Council Feedback on Proposed Mixed-Use Development – 135 Badgerys Creek Road, Bradfield

Attachment A – Detailed Commentary

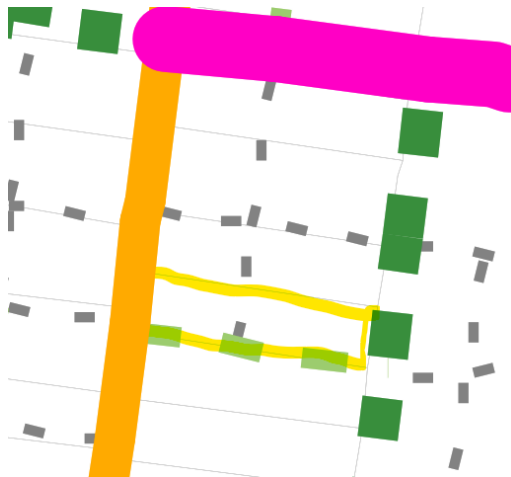
TfNSW is currently preparing a design plan to widen Badgerys Creek Road to a 4-lane urban road. The subject site is affected by the proposed widening. Hence, consultation is required with TfNSW regarding the required road reserve on the subject site.

The BDA is currently constructing the centre loop west and Road No. 7. The development site is to incorporate the approved design layouts of Road No. 7 and the Centre Loop West Road to the site plan.

The proposed new local road on the subject site should be designed in accordance with the Western Sydney Aerotropolis DCP 2022 and Austroads Guide. Consultation is
